2020 Corvette: Service Bulletin: #N202302840: Service Update - Door Paint Chipping

Subject: N202302840 — Door Paint Chipping
Models: 2020 Chevrolet Corvette

Release Date: April 2020

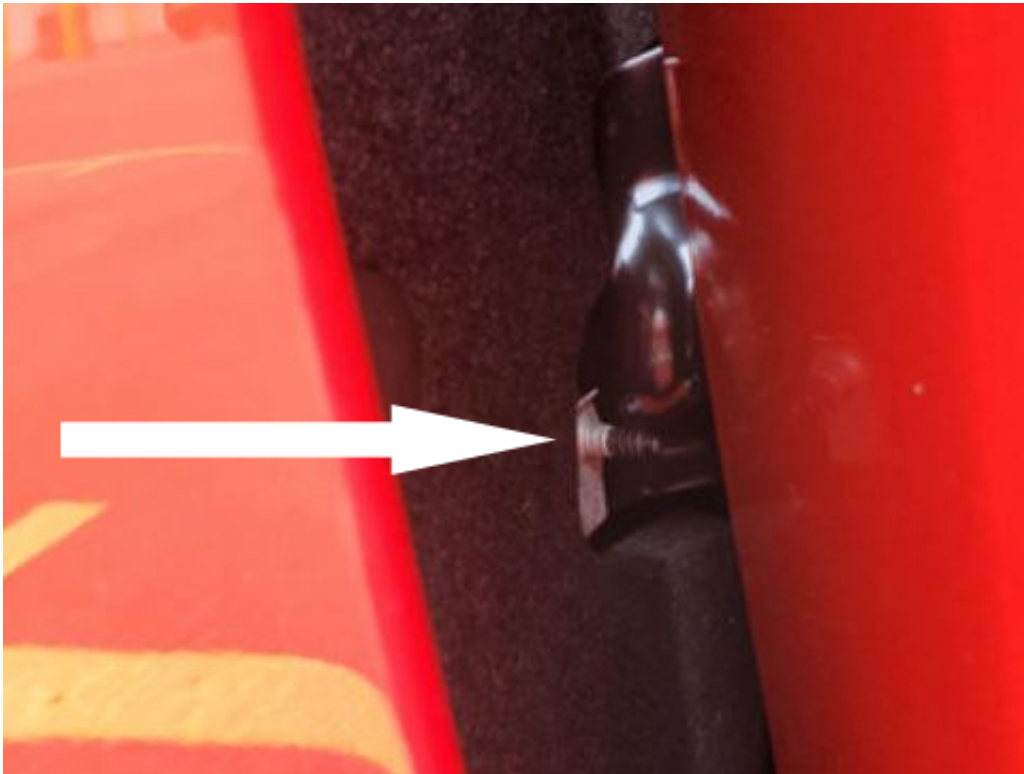
1. Carefully open the left front door inspecting for any contact with the fender fastener. This fastener is located just below the door check strap area.
2. Locate the threaded portion of the fender mounting bolt where it exits the nut.
3. Count the number of threads showing.

- If less than 1 full thread is showing, no further action is required.

- If more than 2 threads are showing, proceed to step # 4.
 - Partially remove the wheelhouse liner to access the rear fender mounting fasteners. Refer to *Front Wheelhouse Liner Replacement* in SI.
1. Locate and remove the center fender to body fastener as shown.
 2. Install the shorter service fastener. Tighten 9 Nm (80 lb in).
 3. Reinstall the wheelhouse liner. Refer to *Front Wheelhouse Liner Replacement* in SI.
 4. Repeat steps 1-7 on the right side of the vehicle.
